**Thanet District Council Stage 2 Design Options Response**  
**Friday 22nd May 2020**

Notwithstanding any views on the future of the Airport site, Thanet District Council welcomes the opportunity to provide comments on the developing design options for departures from and arrivals to runway 28 and runway 10 at Manston Airport. These comments are based on the revised Appendix A submitted to the Council on Tuesday 12th May 2020, specifically the figures in Annexes A1-A4.

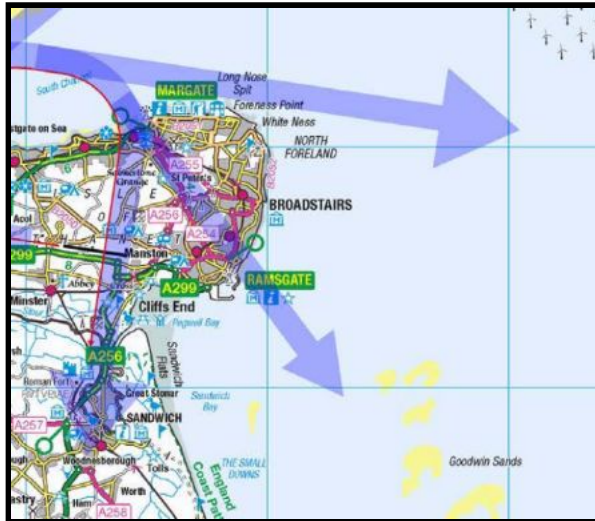
- Figure 1 Runway 28 Left-Hand Departures travelling in the northerly direction and north-easterly direction should not be used.

- Figure 2 Runway 28 Right-Hand Departures travelling in the easterly direction, south-easterly direction and southerly direction should not be used (shown below).
